RECEIPT (DATE: 11/2/22 ONSITE SEWAGE DISPOSAL SYSTEM P 572675
APPROVAL I	DATE: 7/18/2023 PERMIT: CONSTRUCTION A
	DDRESS: 8232 White Pine Court
SUBDIVISION	I: Fulton Hill LOT: 4 TAX ID:
CONTRACTO	R: Freedom Septic EMAIL: <u>Xristy@freedomseptic.com</u>
CONTRACTOR	ADDRESS: 2809 Liberty Road, Sykesville, MD 21784 PHONE: 410-795-2947
CONTRACT	TOR CERTIFIED FOR BAT INSTALLATION: MDE MANUFACTURER:
PROPERTY O	WNER: Cairn Custom Homes EMAIL:
OWNER ADDR	RESS: 10548 Gorman Road, Laurei, MD 20723 PHONE:
BAT UNIT MO	ODEL: Norweco TNT 750 PUMP SIZE: N/A PUMP TANK CAPACITY: N/A
OPERATION &	MAINTENANCE AGREEMENT DATE SIGNED: 4/21/2023 DATE RECORDED: 4/21/2023
DISTRIBUTIO	N SYSTEM: GRAVITY PRESSURE DOSED BEDROOMS: 6 APPLICATION RATE: 1.2
TOFNELIES	2.6 top trench+(0.9 pipe LINEAR FEET REQUIRED: 125 3@42 INLET DEPTH: invert)
TRENCHES:	TRENCH WIDTH: 2 MAXIMUM BOTTOM DEPTH: 8
	MINIMUM SPACE BETWEEN TRENCHES: 11 EFFECTIVE AREA BEGINNING DEPTH: 3.5

OPERATION AND MAINTENANCE AGREEMENT FOR AN ON-SITE SEWAGE DISPOSAL SYSTEM HAVING AN ADVANCED PRE-TREATMENT SYSTEM

The BAT plan for 8512 White Pine Court has been reviewed with the following comments:

FULTON HILL LOT 4 (8512 White Pine Court) PLAT No. 25976

SEPTIC TRENCH SECTION DETAIL NO SCALE

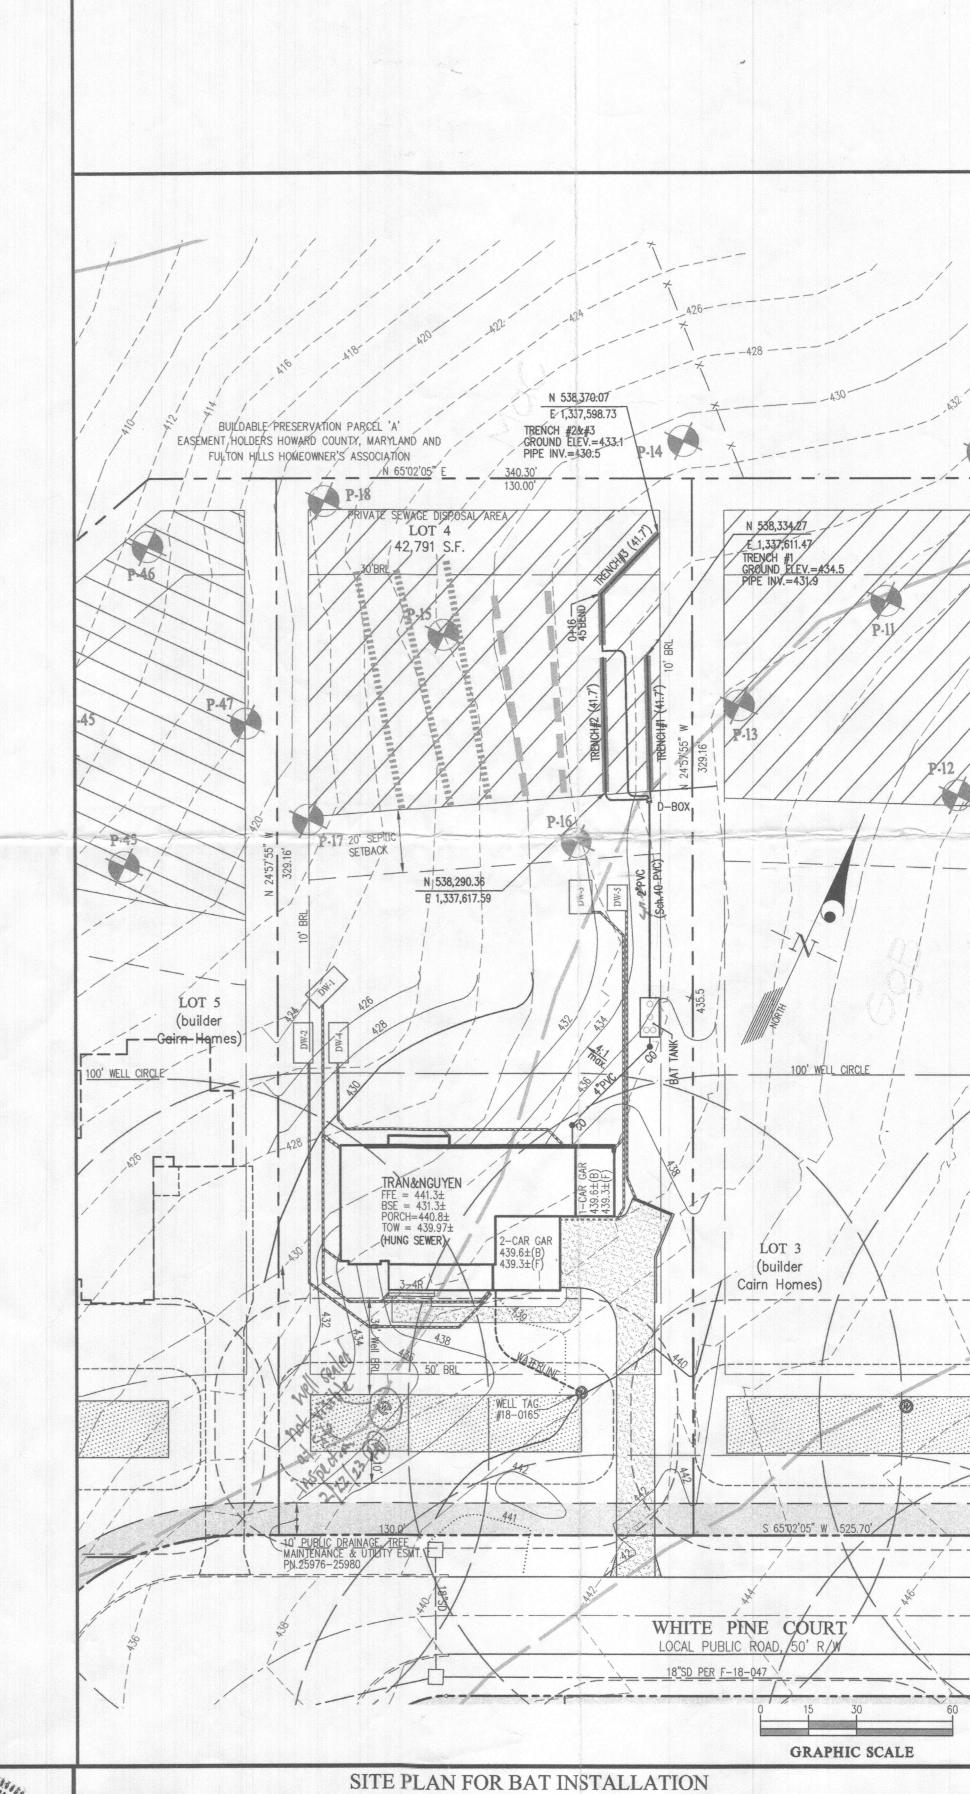
- 1.) Trench detail located just above the trench elevation chart shows trench depth greater than 8 feet (8.5 feet).
- 2.) Trench detail also shows the invert elevation at 2.5 feet, and the trench sizing calculation chart shows the invert elevation at 2.6 feet.
- 3.) SDA trench elevation chart shows effective area starting at 6 feet (434.5 428.5 = 6 feet).
